Expert Report

Estimate in Respect of INTC No. 429

MUDFA programme Revision 8

The Edinburgh Tram Project

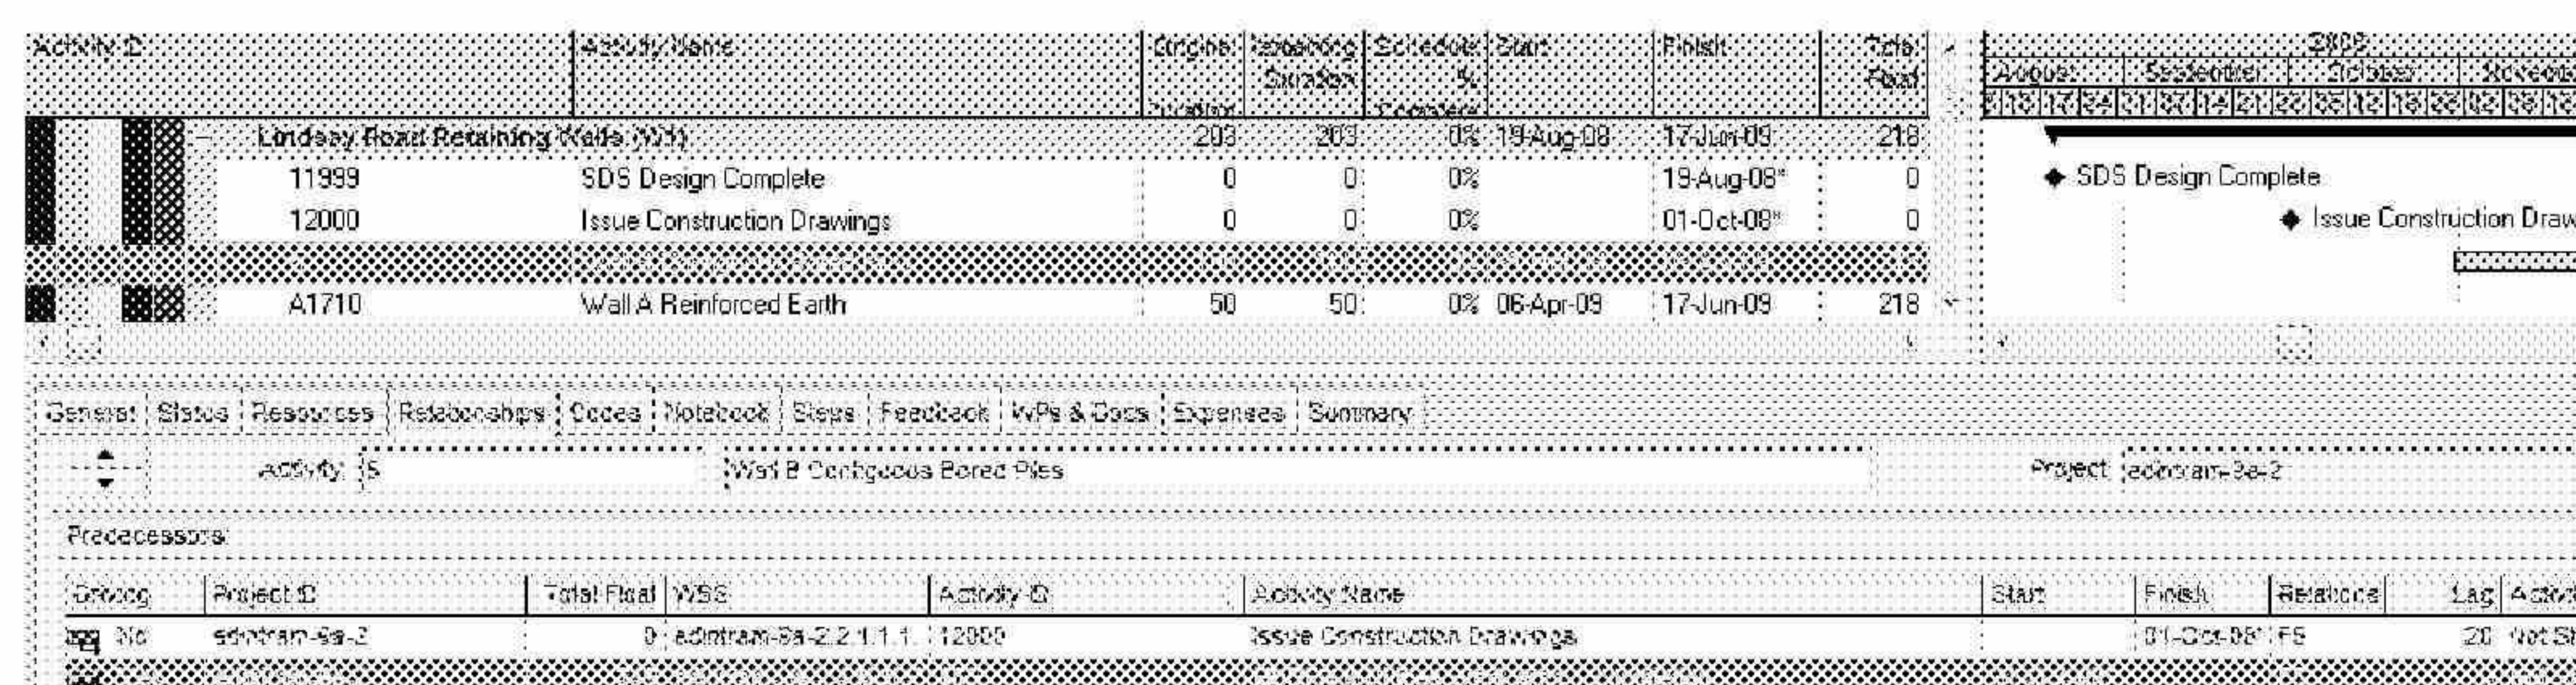
- d) The Infraco’s Estimate states that the 10 No. dates constitute the start milestones for the Infraco Works in the corresponding Intermediate Section. Examination of the Programme in its native software format evidences that this is an inaccurate statement. I cite as an example Section 1A. Along the length of this intermediate section there are three locations where different sequences of work activities commence. These are:

evidences these observations which show that the MUDFA milestone date is not on its own the “start milestone” for the Infraco Works.

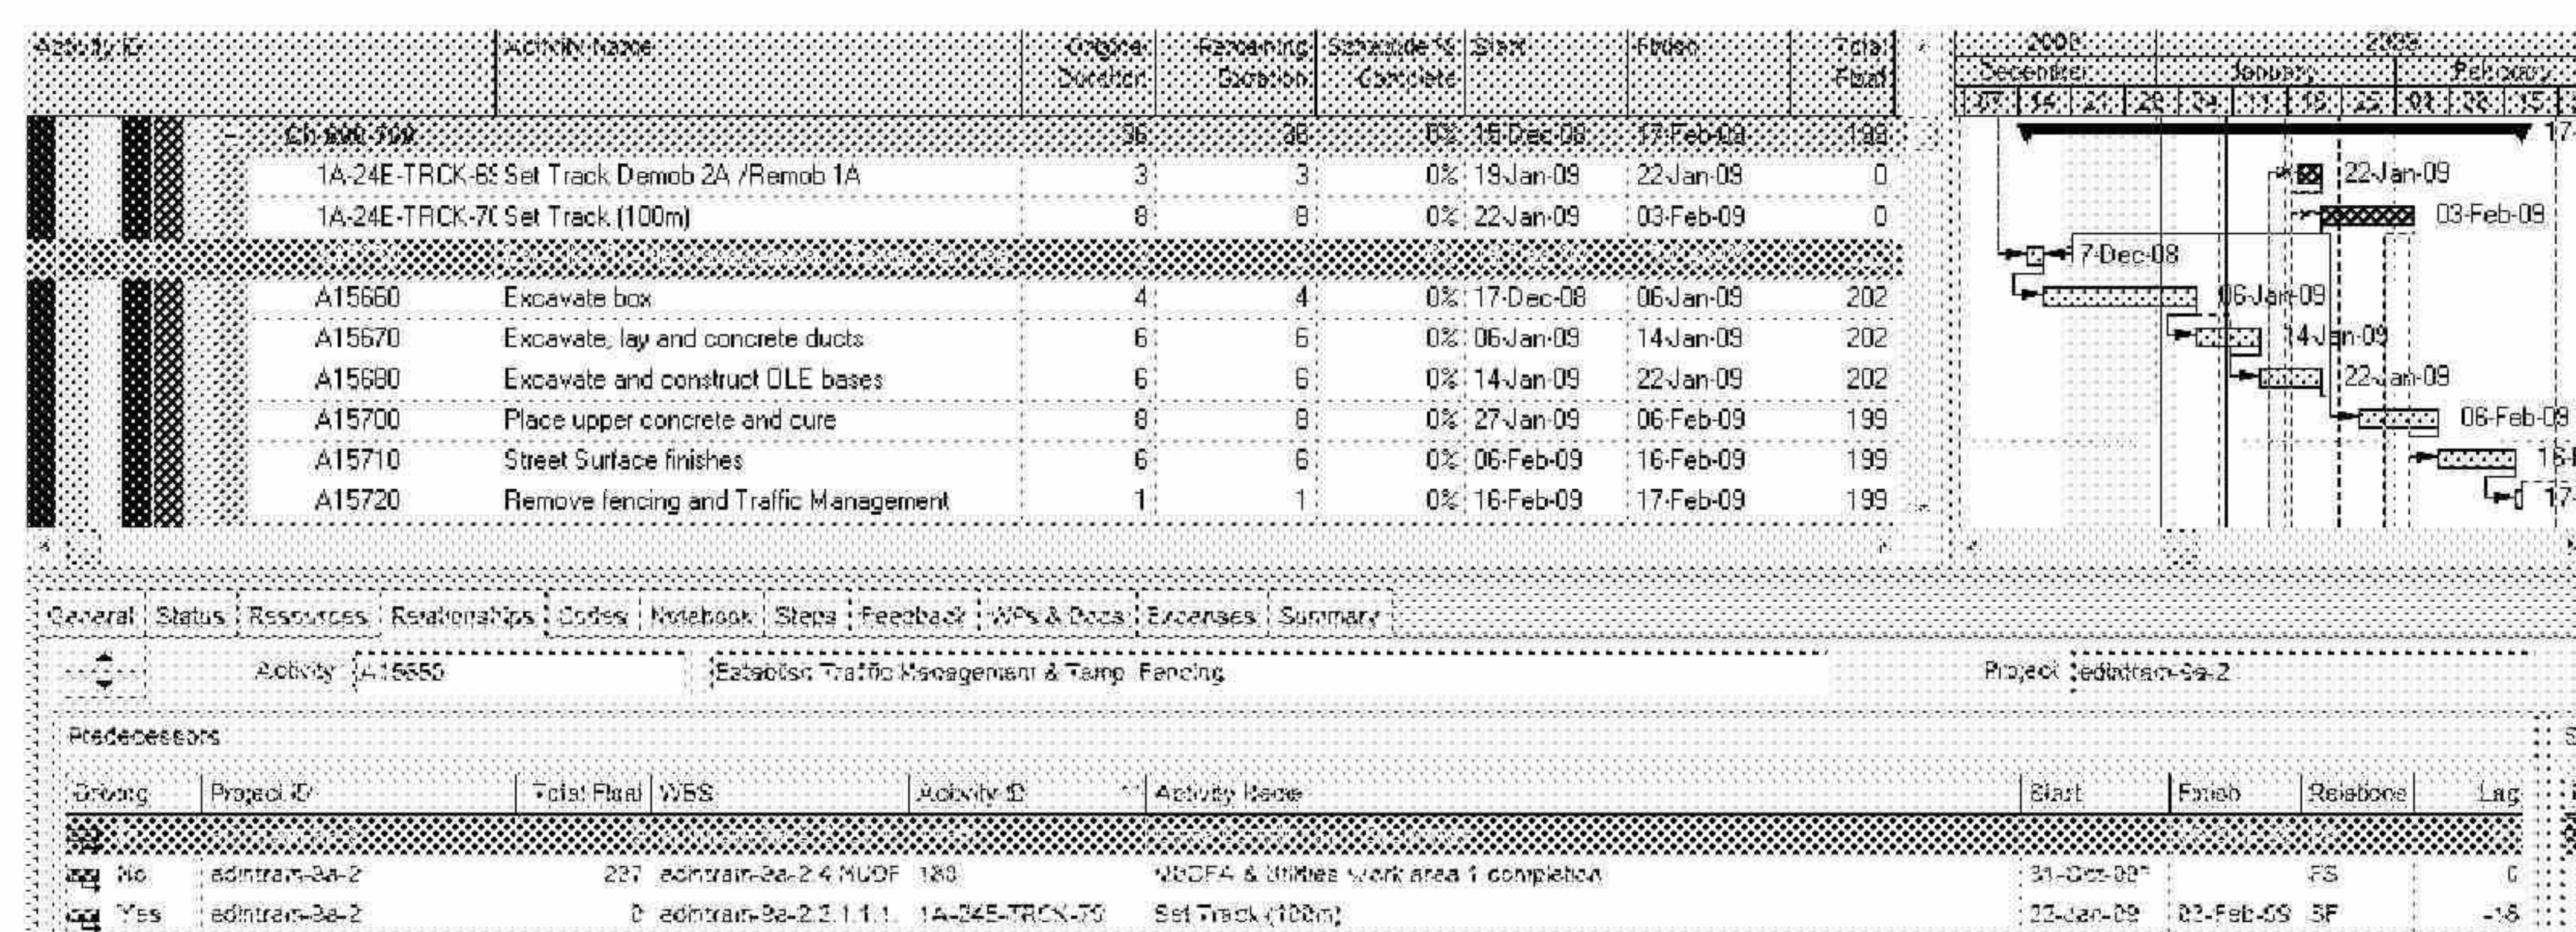
- f) The Ch 600 – 700 road and track activities set have three predecessors. The first two, “Issue Construction Drawings” and “MUDFA & Utilities work area 1 completion” are not driving activities. It is the third predecessor, a start-to-finish link (with a minus 16 days lag) to the “Set Track (100m)” activity that is determining the start of the road works, as shown on the programme extract below. The start of that activity is being driven by a preferential logic link to track laying in Intermediate Section 2A. This is a work activity located approximately 6km to the west of this location. Clearly, there is no physical interdependency between these activities. (Refer to paragraph 5.2.5f) for explanation of physical and preferential interdependencies.)

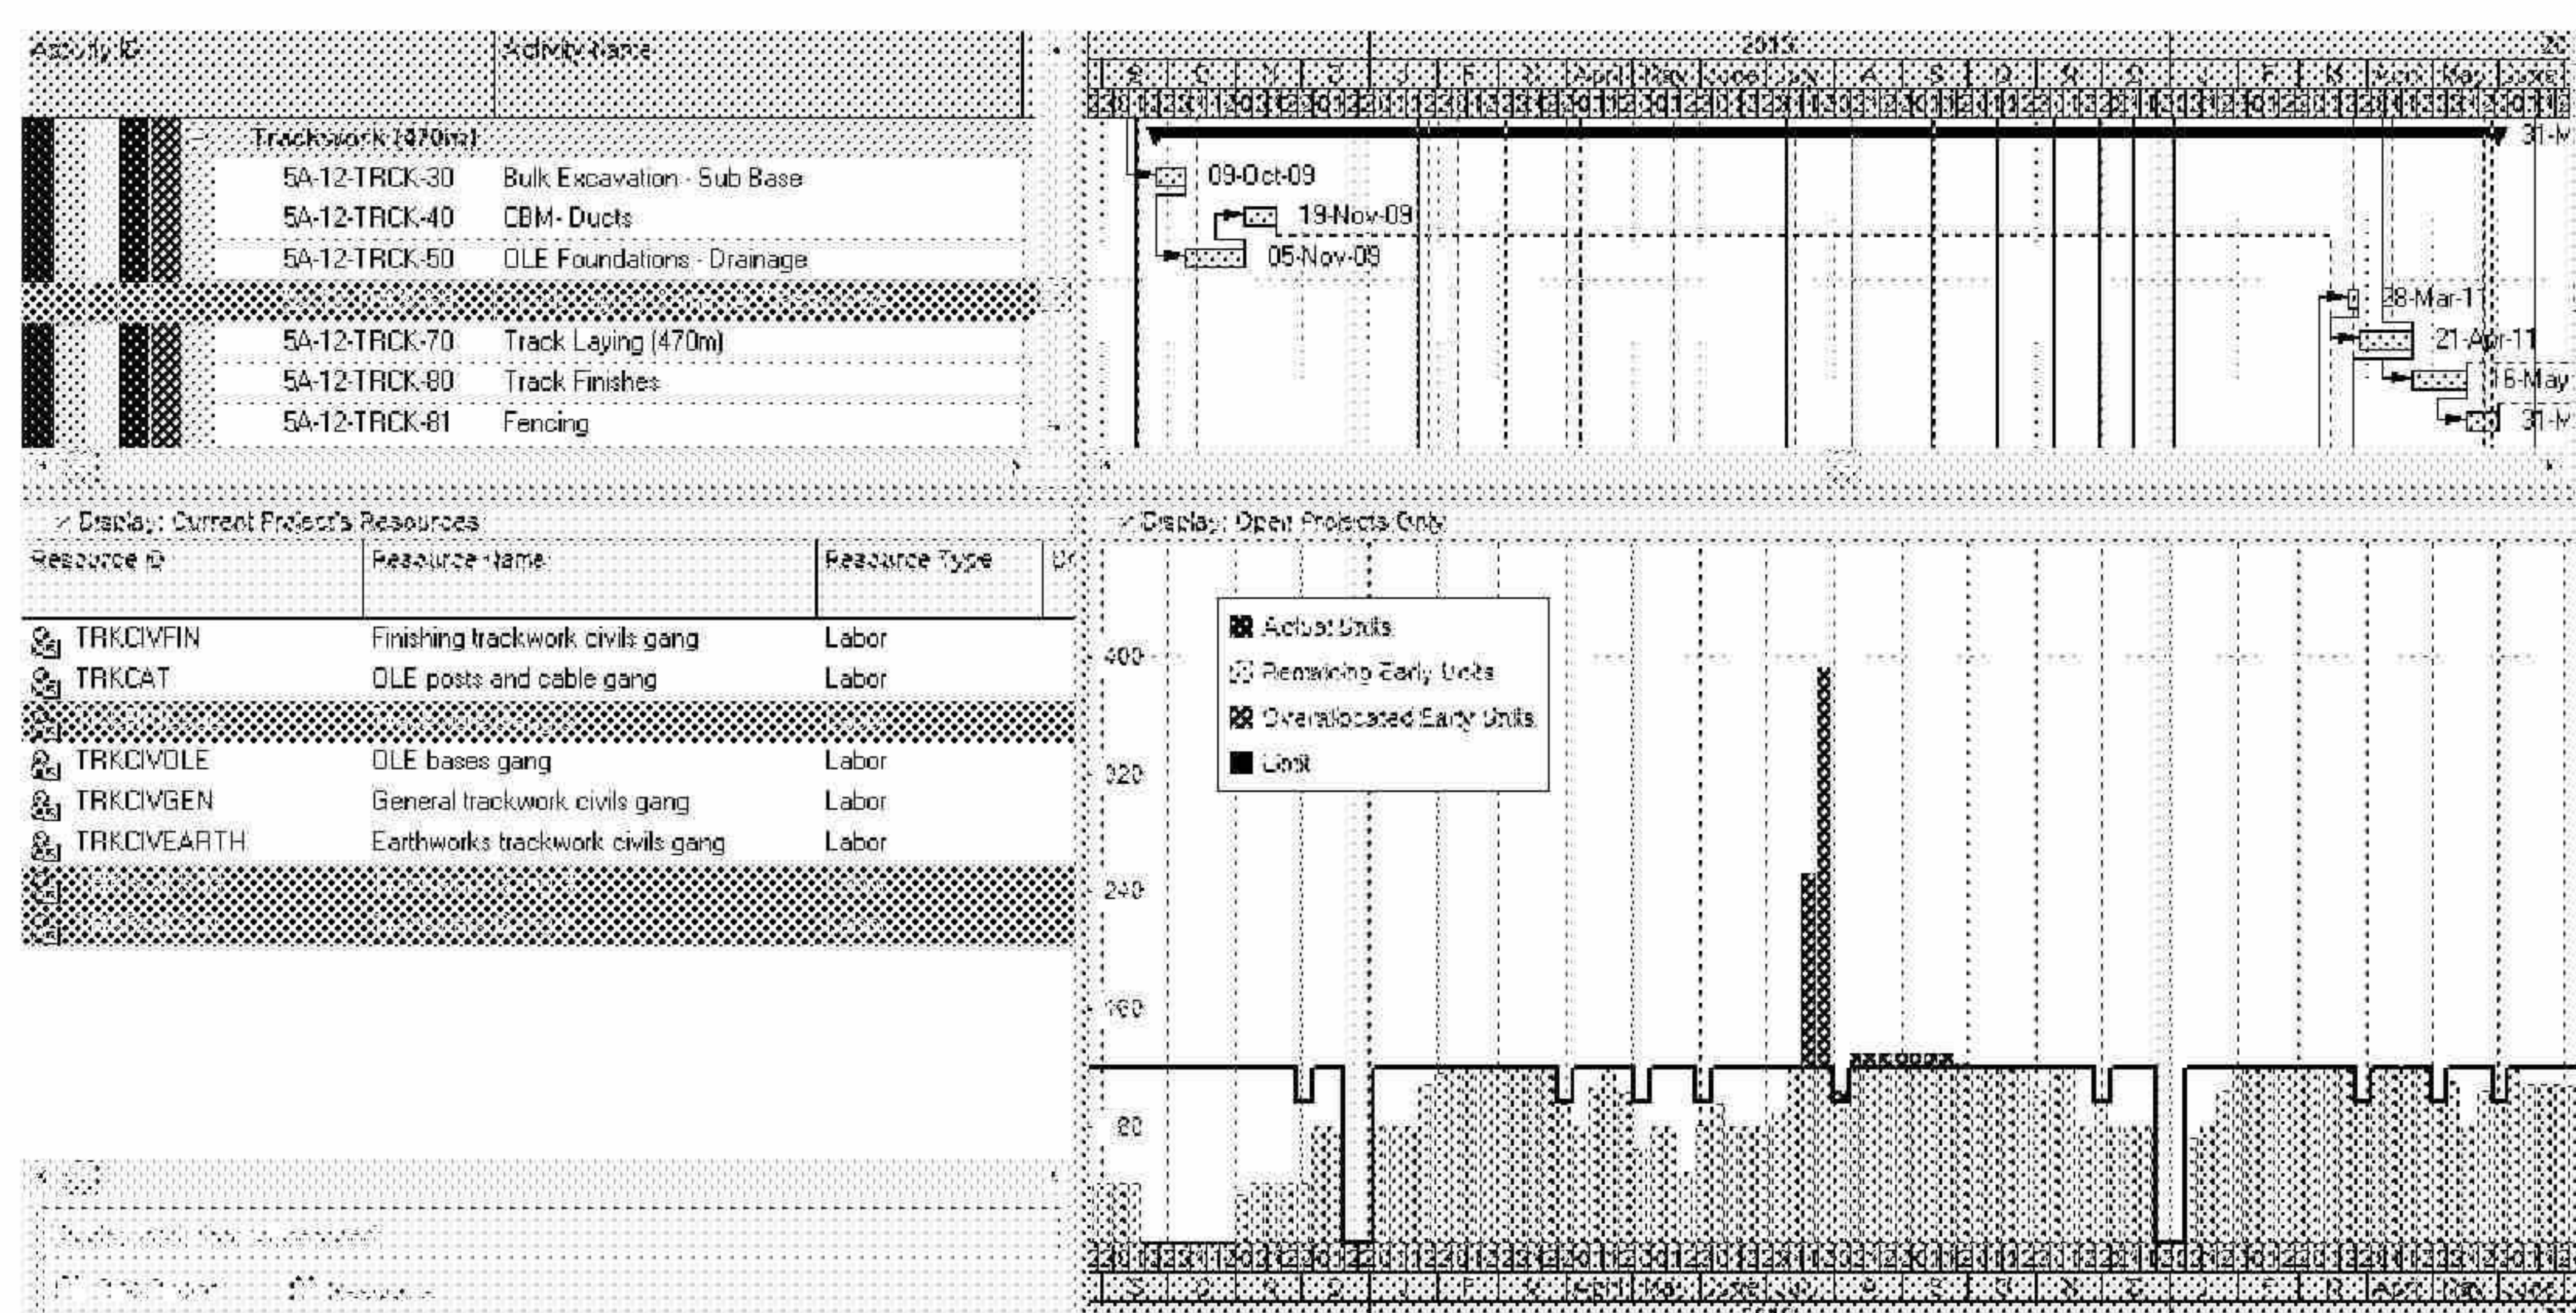
- f) Of even greater significance to the accuracy of the Infraco's delay analysis is the network logic I have examined within the soft copy of the programme. It contains both physical and preferential logic links⁴. Much of the critical path is driven by the preferential logic links. For the most part these preferential links have been inserted to effect contractor imposed constraints on the availability of certain resources (i.e. 3 No. track laying gangs and 2 No. overhead line gangs). By impacting the MUDFA delays by revising the date for the 10 No. MUDFA milestones these preferential logic links greatly exaggerate the true impact of overall delay. This is because they rigidly adhere to the original resource constraining activity sequences despite the relative timings of the different activities being changed by the different amounts of delay being impacted into each Intermediate Section of the programme. The following paragraph and Appendix 5/2 evidence this exaggeration of projected delay.
